CSC Set 2
Interrogatory CSC-1

The United Illuminating Company
Docket 317

Trumbull Substation Project

Feeder Routes
 Site 6A

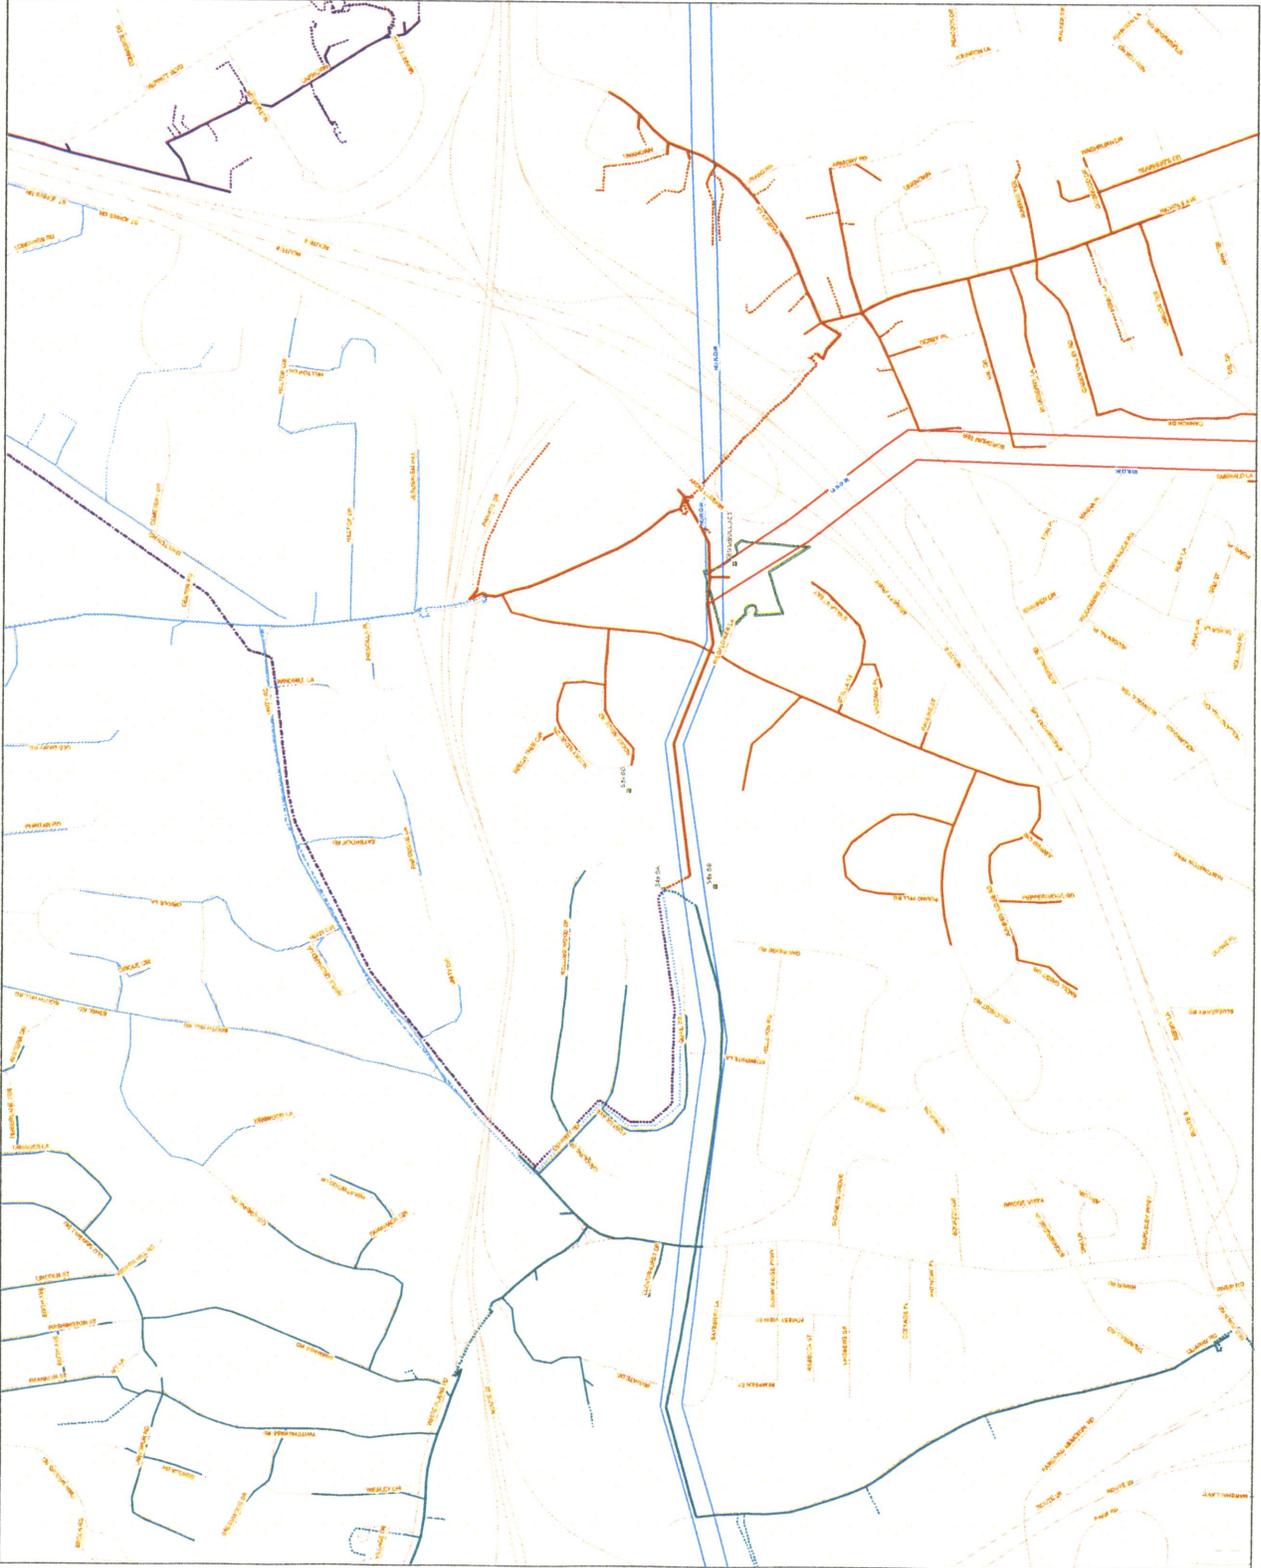
Q-CSC-2: How many distribution feeders would leave the substation from sites 6A, 6B, and 6C? What direction would they go to connect to the distribution system?

From sites 6A and 6B, feeders 3547 and 3545 will exit the substation in duct line on Quail Trail that will be extended north of the Merritt Parkway. Feeders 2620 and 2627 will exit the substation underground onto the right-of-way and rise to open wire.

A map of the proposed feeder routes for the four original feeders is attached as CSC Set 2, 2-1, 2-2 and 2-3 for Sites 6A, 6B and 6C respectively.

Homes within 1000ft
 of Site 6A, 6B, 6C
 Trumbull, Connecticut

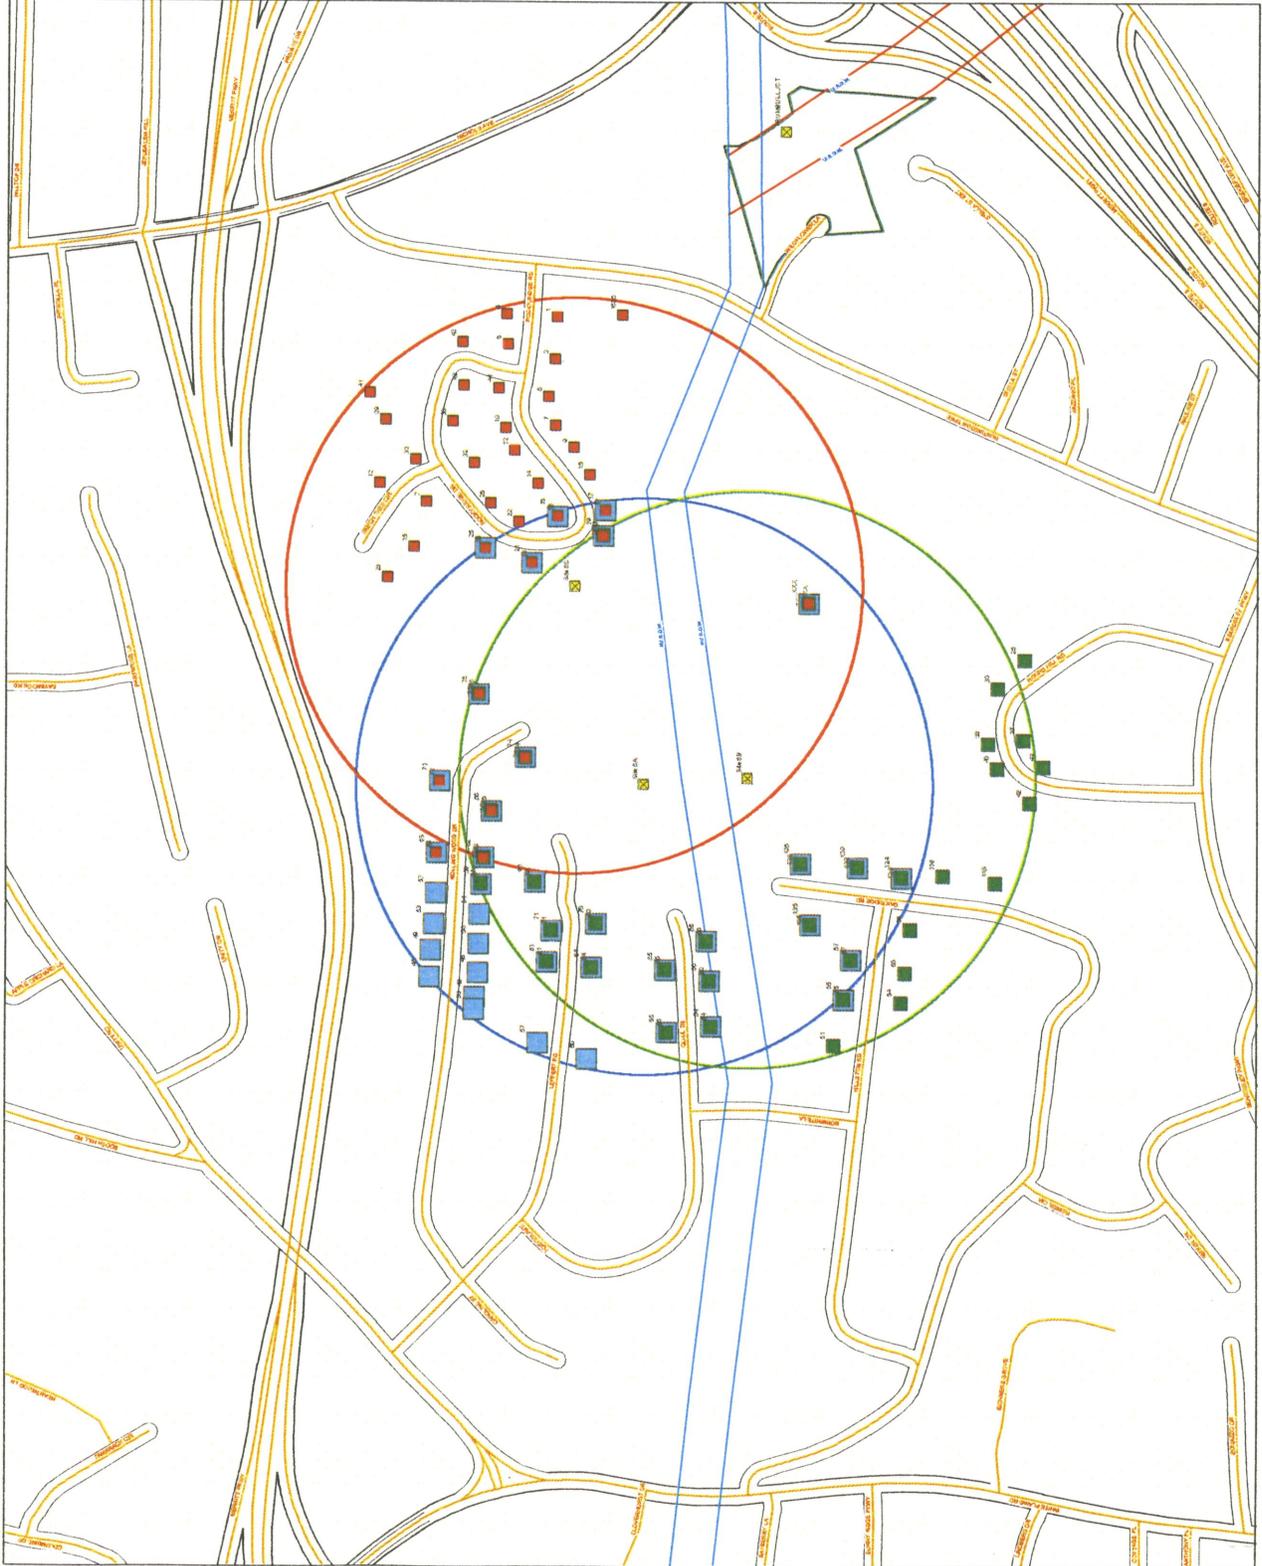
Q-CSC-4: Approximately how many homes are within a 1000' radius of the center of the following sites: 6A, 6B, and 6C?

Site	Number of Homes
Site 6A	45
Site 6B	36
Site 6C	38

A map illustrating these homes is included as CSC Set 2, Exhibit CSC 4 -1.
